Access Compliance Report

Public Rights-of-Way

| Intersection ID: 25033 | Main Street: ARBORETUM_VIEW | Cross Street: PINEVILLE-MATTHEWS_RD | Location: NW |
| ADA ID: D94158375BA8 | Ramp Type: PerpDiag | Initial Pass/Fail: Fail | Overall Compliance: No |

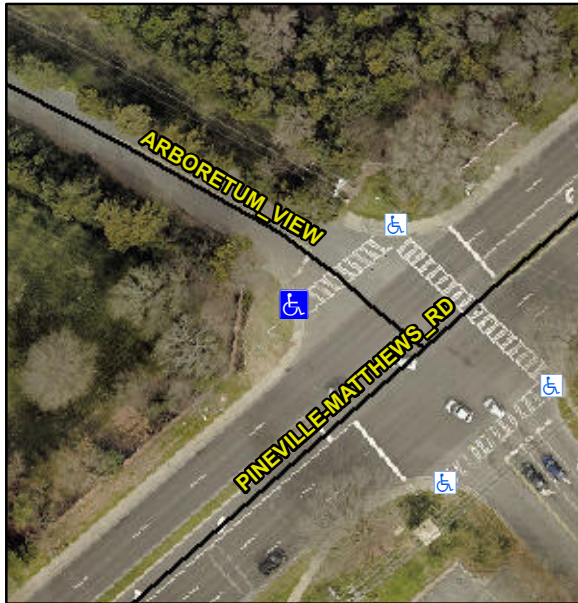
R304.2.2, R304.5.3

| Compliance | Description | Data | Compliance | Description | Data |
|------------|-----------------------|-------|------------|-----------------------------|-------|
| N/A | Ramp Length (in) | 60.0 | No | Ramp Slope (%) | 10.1 |
| Yes | Ramp Width (in) | 48.0 | No | Ramp XSlope (%) | 7.6 |

Remove & Replace Curb Ramp With Two New Directional Ramps or Equivalent.
